SYLWADAU NMC367 COMMENTS

**Cynllun Datblygu Lleol ar y Cyd Ynys Môn a Gwynedd 2011-2026
FFURFLEN SYLWADAU I NEWIDIADAU MATERION SY'N CODI/
Anglesey and Gwynedd Joint Local Development Plan 2011-2026
MATTERS ARISING CHANGES COMMENTS FORM
26/1/17.**

Stad Diwydiannol Griffin (Newidiadau Materion sy'n Codi)
Griffin Industrial Estate (Matters Arising Change)

Elthriot safle o'r Gwarchodfaeth Cyfogaeth /
Exclude site from the safeguarded employment site

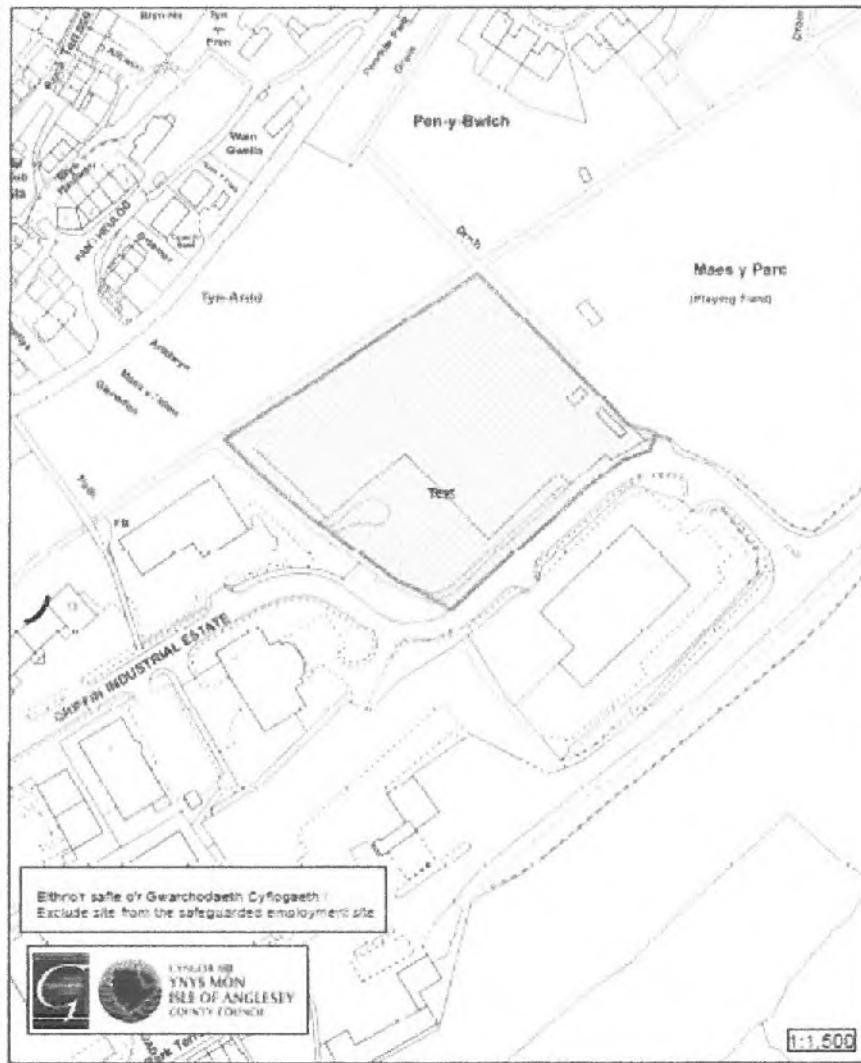
We note and welcome the proposal to exclude the area hatched red on the map from allocation reference C39. We confirm that this removes our objection to the proposal to safeguard and reserve site reference C39 for employment use.

As previously advised, unlike the rest of the land that forms allocation reference C39, the land within the area hatched red was not raised as a result of land-fill - the reason for this is that this land has historically been allocated as a place to store floodwater.

In the absence of an assessment of the flood risk, we would therefore be concerned if the level of the land hatched red was raised as this could increase the risk of flooding to land and property in the Penrhyndeudraeth area. In general, we consider that land raising could only considered if equivalent compensatory storage was provided in the vicinity i.e. reducing the level of an adjacent area of land to compensate for raising the site.

As confirmed in our earlier responses, without a detailed assessment of the possible impact on flood risk, we agree to the exclusion of the area hatched red from allocation reference C39.

NLW'S OBJECTION IS TO THE 'INFILLING' OF THE SITE. IN THE EXTANT PLANNING PERMISSION IT CLEARLY STATES THAT A 'FCA' WOULD NEED TO BE COMPLETED BEFORE ANY FURTHER DEVELOPMENT COULD TAKE PLACE ON THE SITE. THIS OBLIGATION ENSURES THAT NO 'INFILLING' WOULD BE ABLE TO BE DONE ON THE SITE.

THEREFORE REMOVING THE DEVELOPMENT BOUNDARY DOES NOTHING TO THE SITE EXCEPT DEVALUE THE LAND AND PUT IN QUESTION THE VIABILITY OF MAINTAINING THE SITE TO THE STANDARDS OF THE BIODIVERSITY OBLIGATION FROM WRUSH GOVERNMENT (MAINTAIN ACCESS AND TREAT INVASIVE SPECIES MAINLY).
